CAMPBELL CITY COUNCIL STUDY SESSION

Subject Study Session – Civic Center Master Plan

Campbell City Hall (Immediate Occupancy)
 70 N. First St, Campbell, CA
 August 22, 2017

Campbell Library (Immediate Occupancy)
 77 Harrison Ave, Campbell, CA
 August 22, 2017

Second Floor Plan

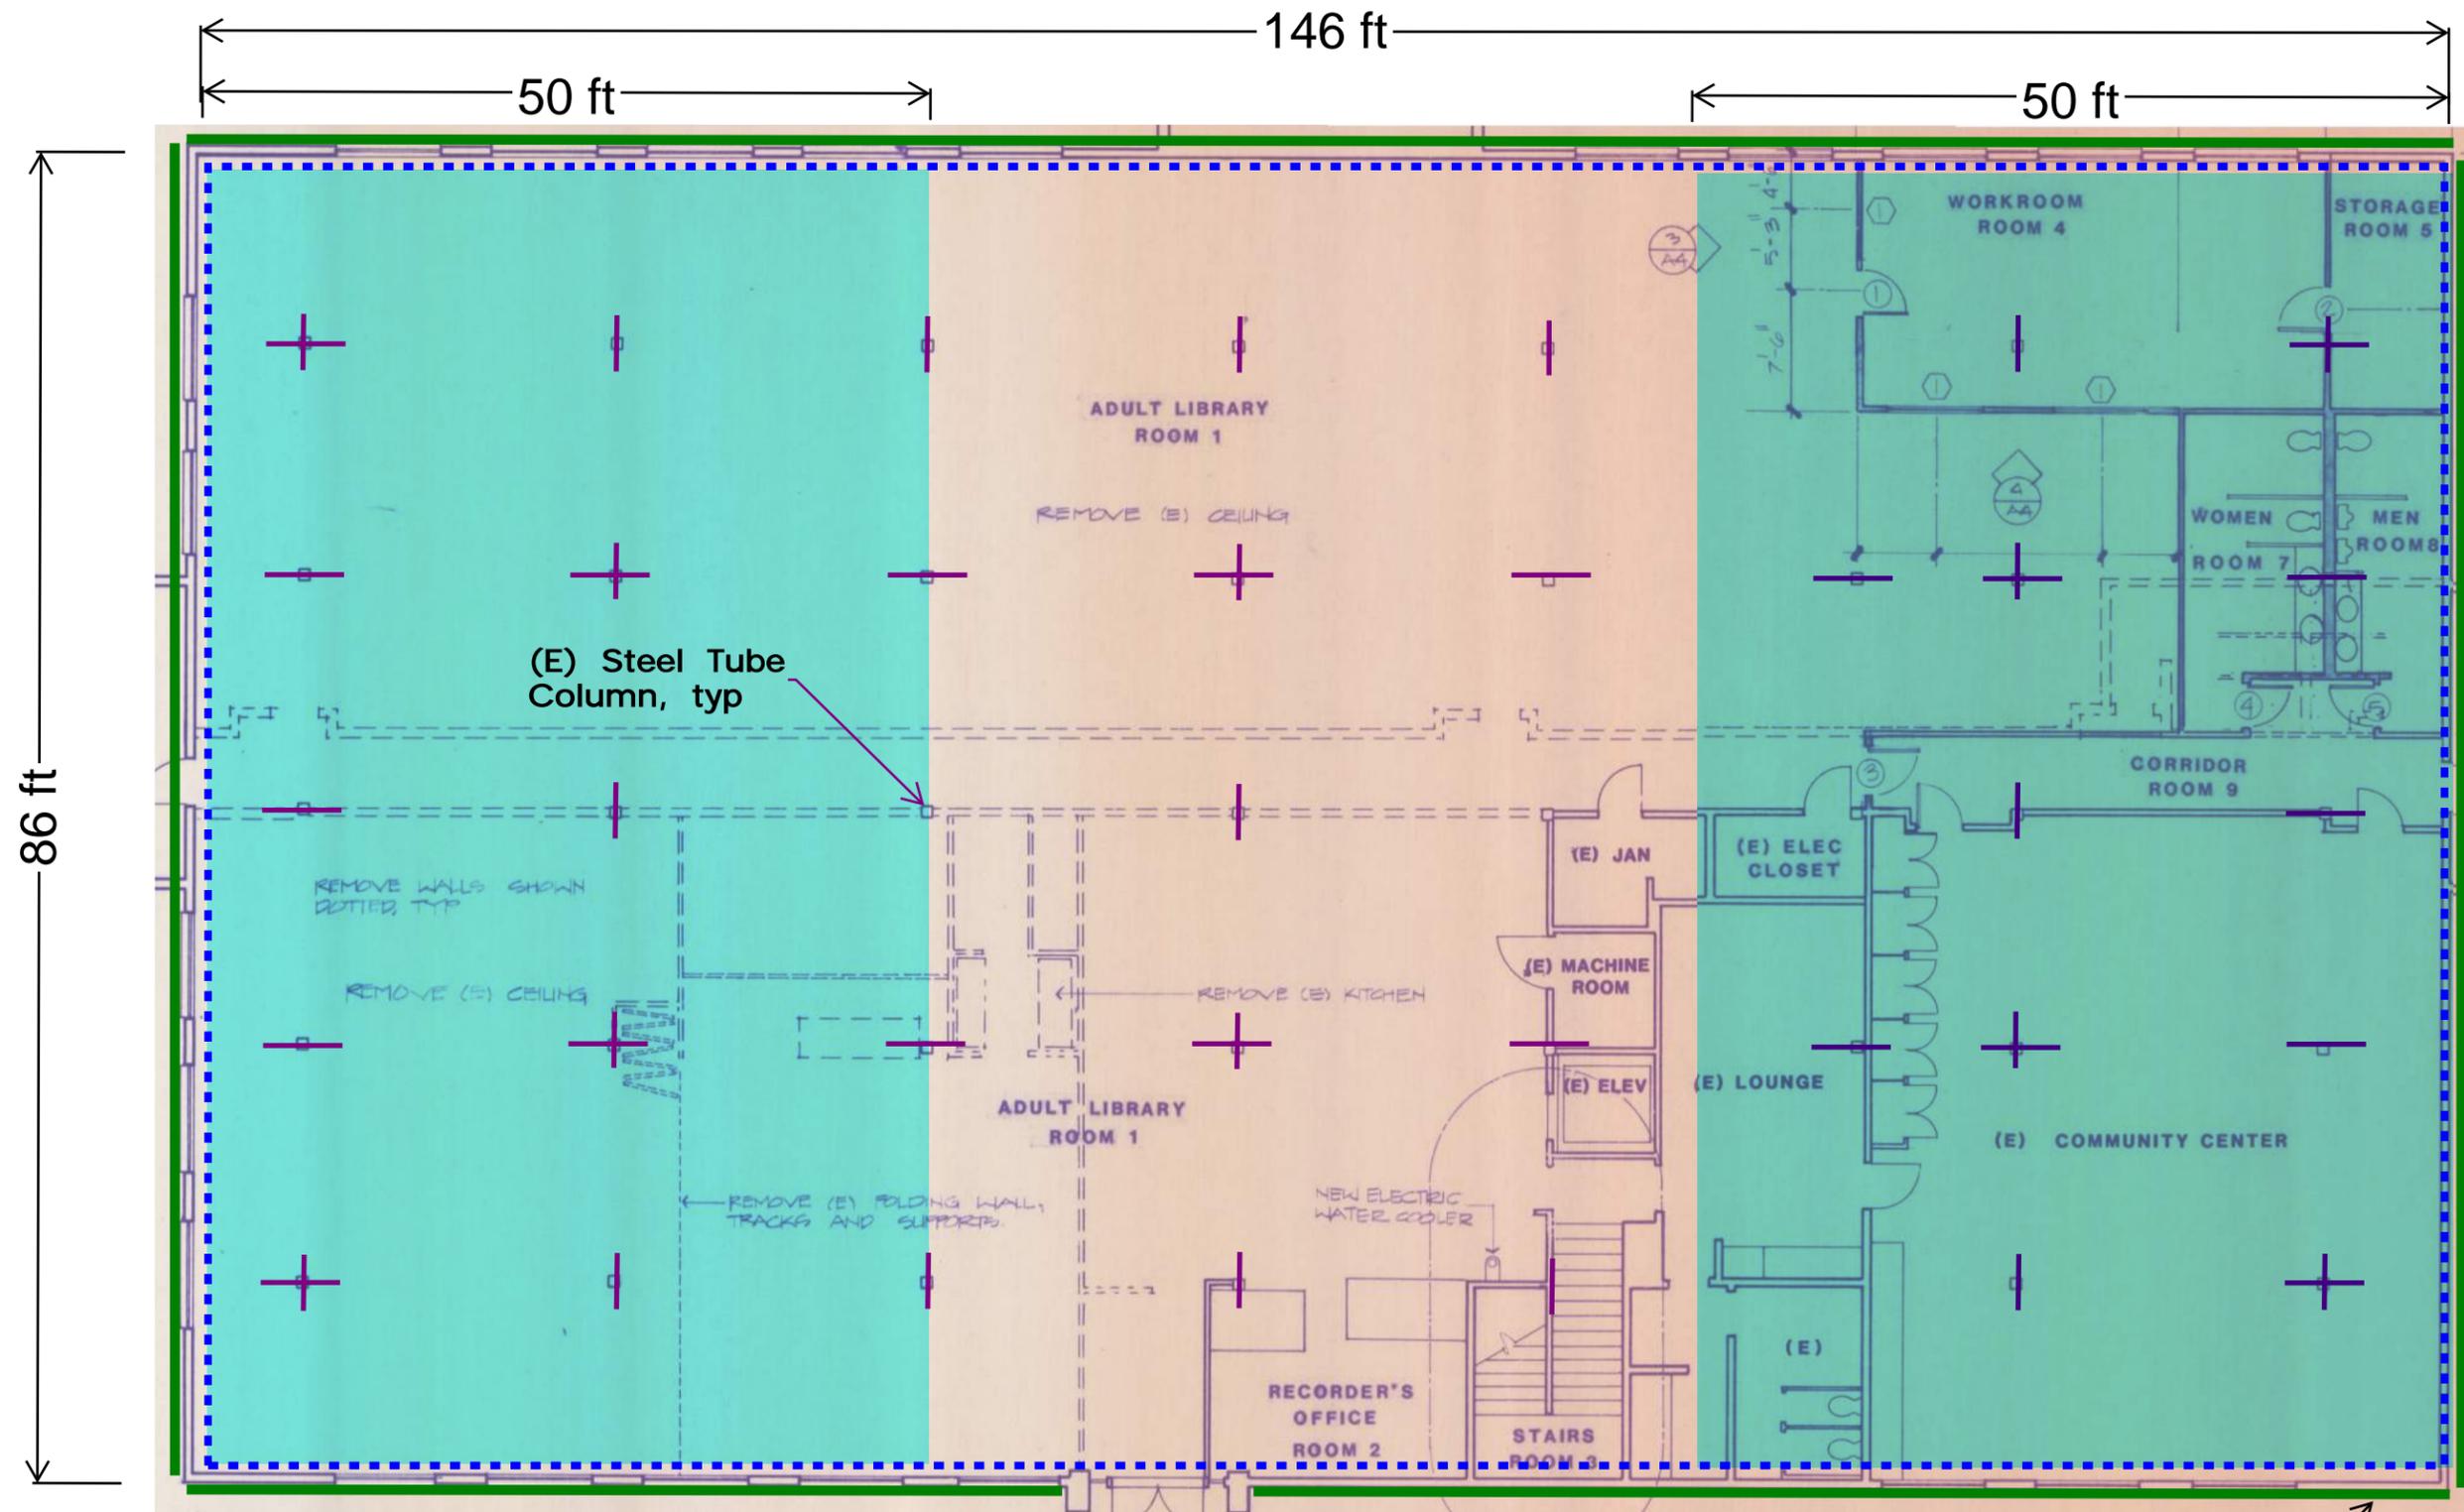
8. At second floor level, masonry wall-to-floor connections appear to be inadequate for both in-plane and out-of-plane wall loads. Addition of new anchor bolts will be required.

9. At second floor level, building cross-ties are inadequate for transferring out-of-plane masonry wall loads into the floor diaphragm. Addition of new horizontal steel straps or steel rods with holdowns is required at beam splice locations (typically at columns).

3. At second floor level, provide new nailing and wood blocking at the plywood diaphragm. [See Deficiency 7 above].
4. At the second floor level, provide new anchors bolts drilled through the existing wood sill plate and epoxied into the top of the existing masonry walls. [See Deficiency 8 above].

5. At second floor level, provide building cross-ties by adding new horizontal steel straps or steel rods with holdowns at beam splice locations (typically at columns). [See Deficiency 9 above].

Roof Plan

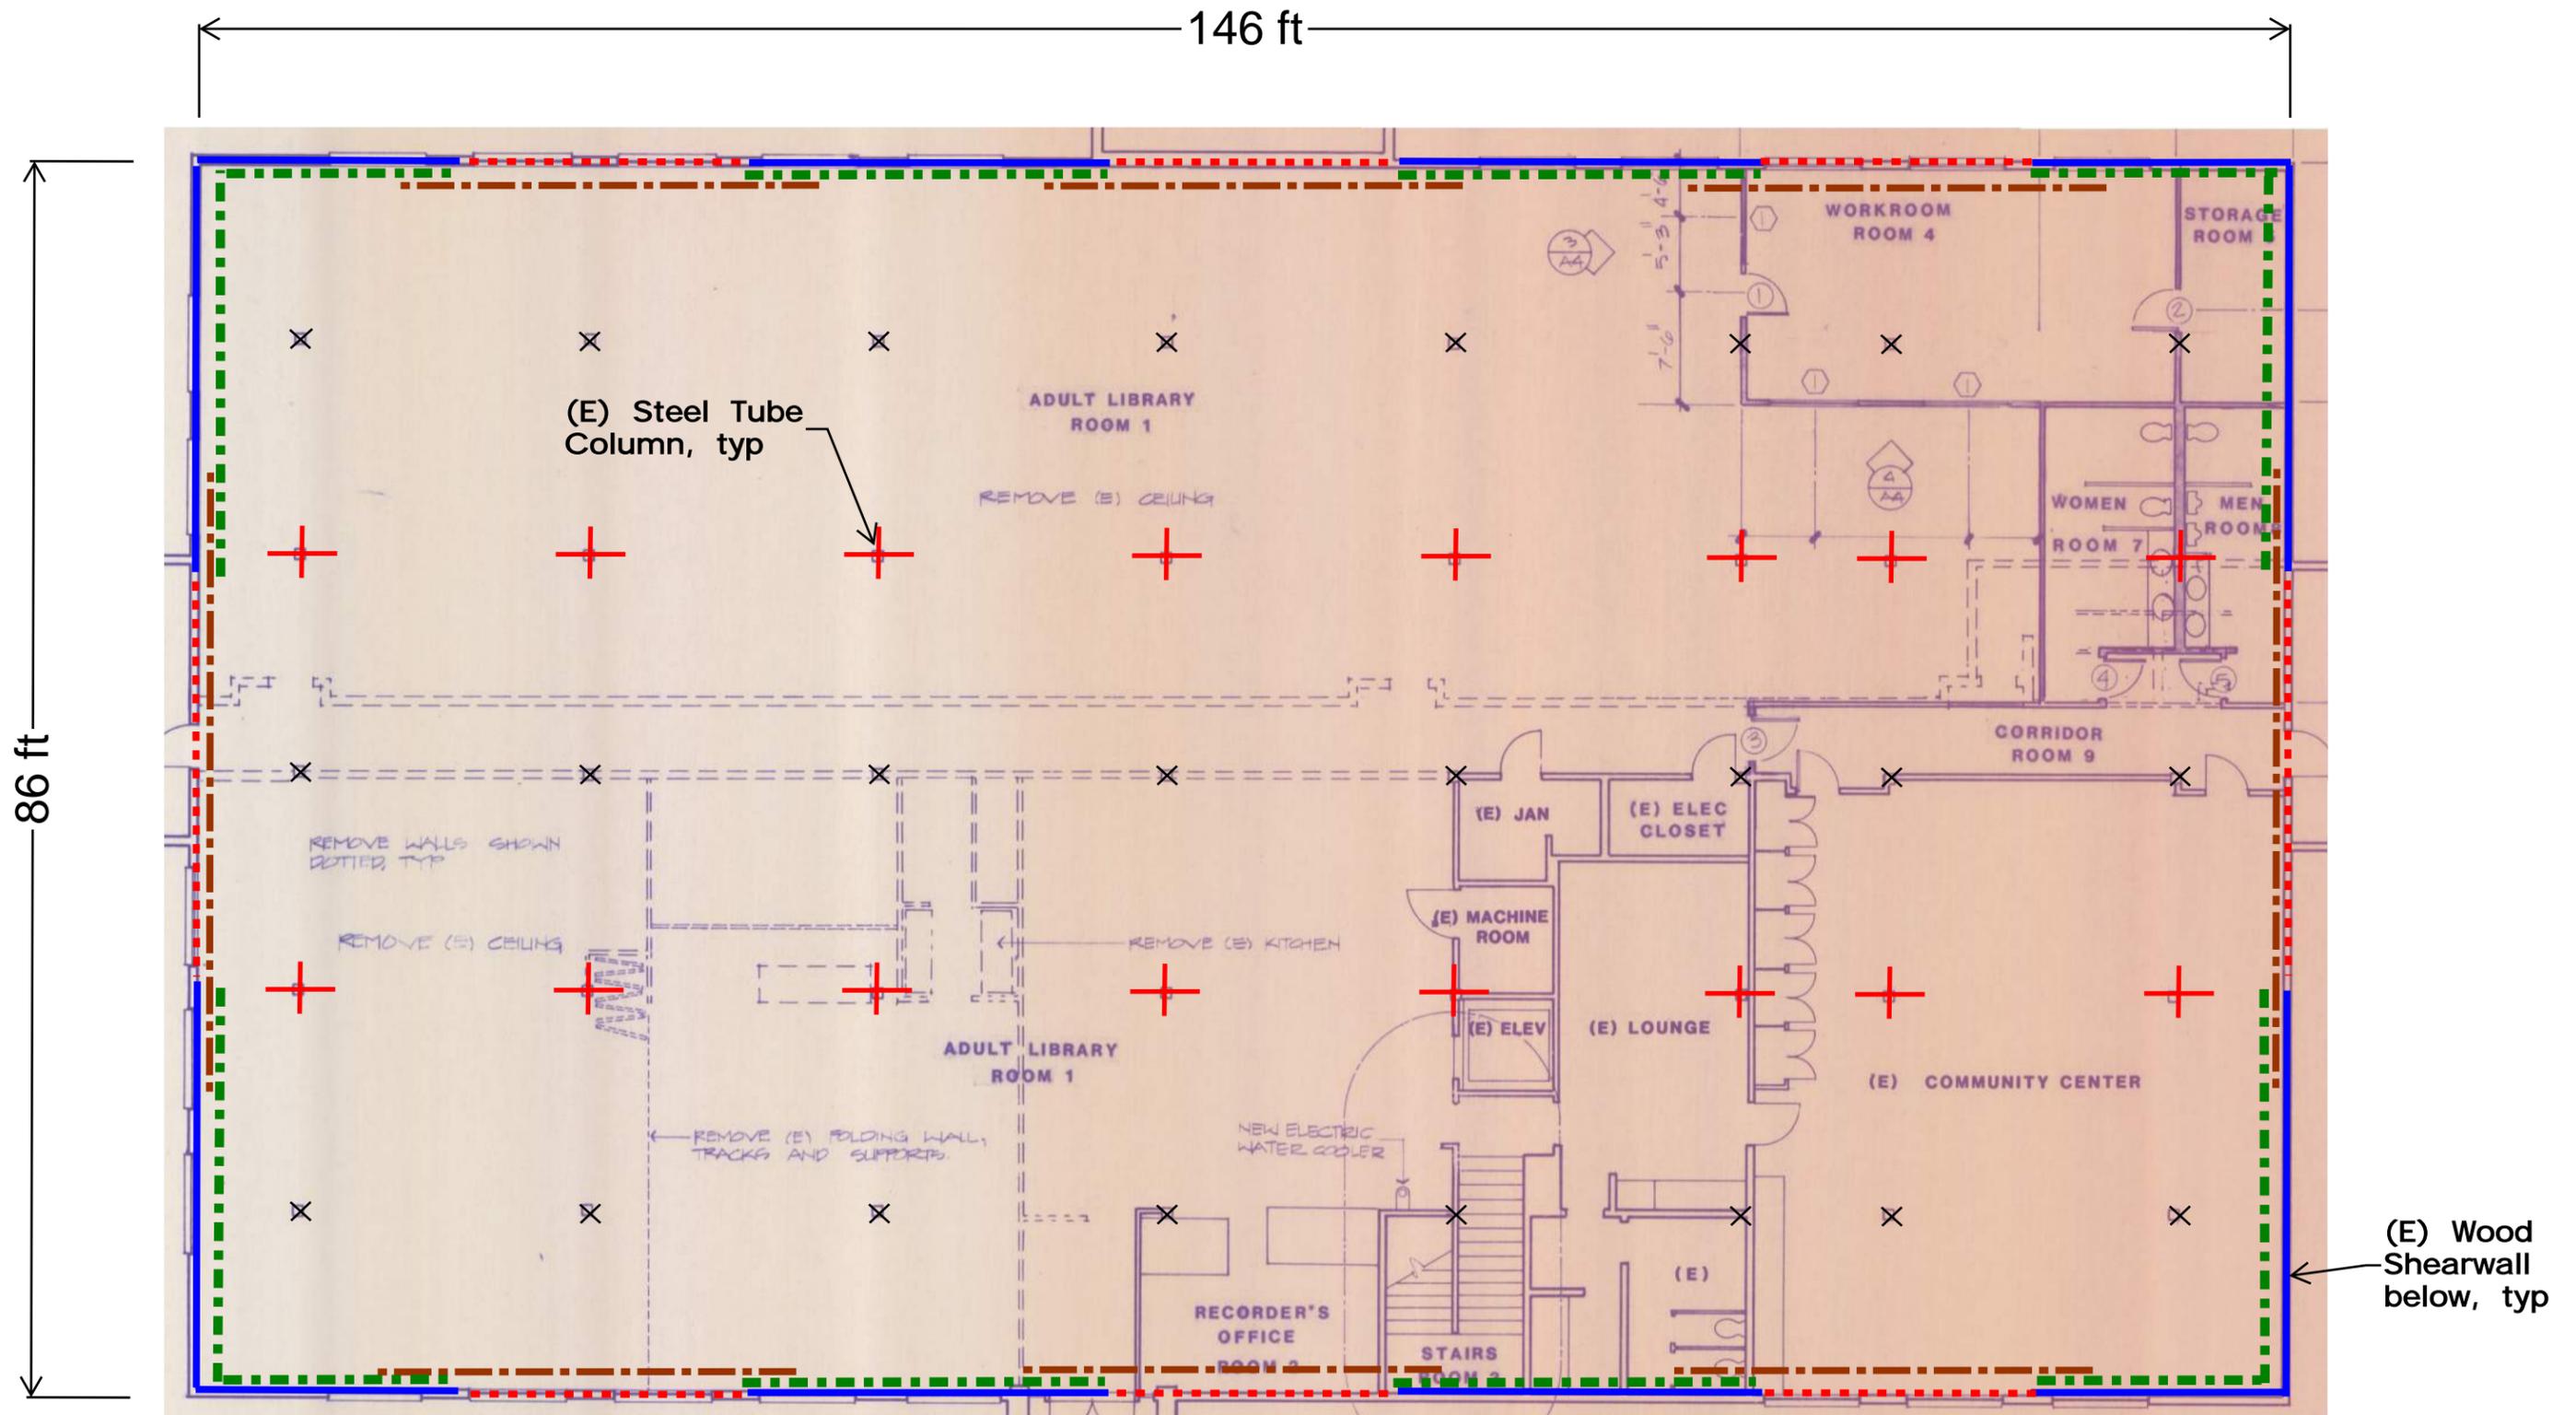
1. At roof level, wood wall-to-roof connections appear to be adequate for out-of-plane wall loads but their details and capacities need verification. If found deficient, new closely-spaced steel straps will need to be added.

2. At roof level, building cross-ties are inadequate for transferring out-of-plane wall loads into the roof diaphragm. Addition of new horizontal steel straps or steel rods with holdowns is required at beam splice locations (typically at columns).

1. At roof level, provide building cross-ties by adding new horizontal steel straps at beam splice locations (typically at columns). These straps will be installed over the roof plywood sheathing, directly above the beams below. [See Deficiency 2 above].

2. At roof level, provide new collectors along shearwall lines by adding new steel straps over plywood sheathing, with new blocking between the joists. [See Deficiency 3 above].
